CORRECTIONS & updates

Evaluation System for 80C166 (parts 1 and 2)

March & April 1999, 990028

990028-11

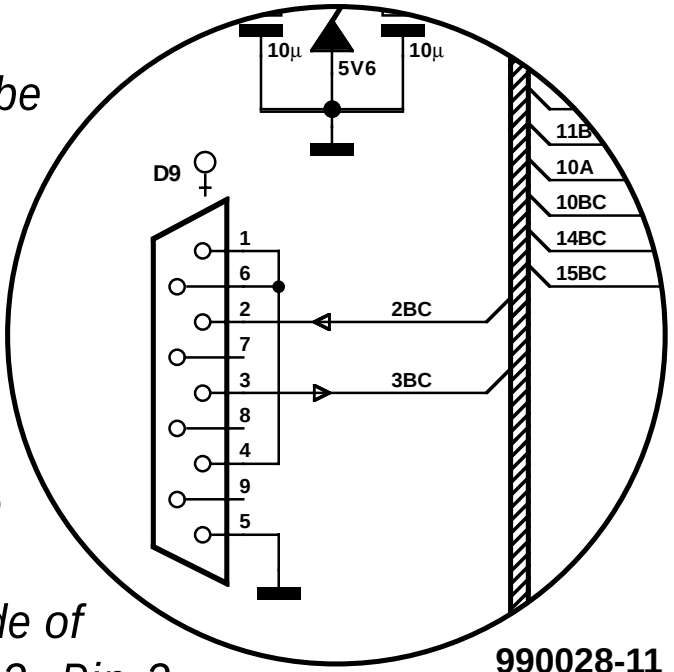
The circuit diagram does not make it clear how the serial connection is made via D9. Pins 2 and 3 of this connector should not be connected TxD1 and RxD1 (i.e. the TTL side of the MAX232), but to the other (RS232) side of the MAX232. Pin 2 of D9 is therefore connected to pin 2BC via bus K1. Likewise pin 3 of D9 is connected to pin 3BC via bus K1. The correct connections are shown in the illustration.
